INITIAL FIRE SAFETY INSPECTION REPORT

KDS Washing Plant

RSC ID: 24482

Date: 15-09-2022

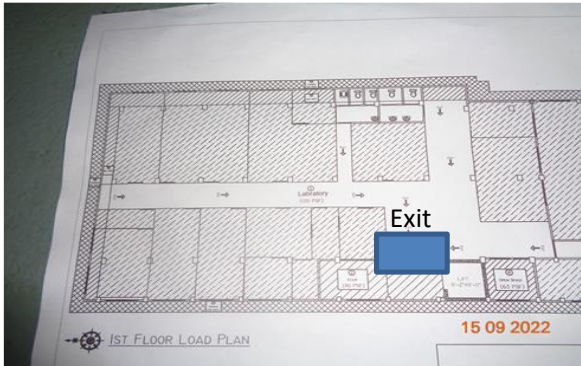
F-3	Fire Rated Construction	Main chemical storage area is not separated by fire-rated construction having unsealed penetrations and openings from washing section, powerhouse and general store. Chemical Sub-store is not separated from WTP having unprotected penetrations. Location: Ground floor of Block B.	Ensure the chemical store fire separated by minimum 4-hr fire rated construction barrier with only occupancies with G and H following table 3.2.1 of BNBC-2006. No opening is permitted in the 4-hr rated wall towards any other occupancy. Follow section 2.13 of BNBC-2006 as a guideline chemical store while rearranging.	Within 3 months
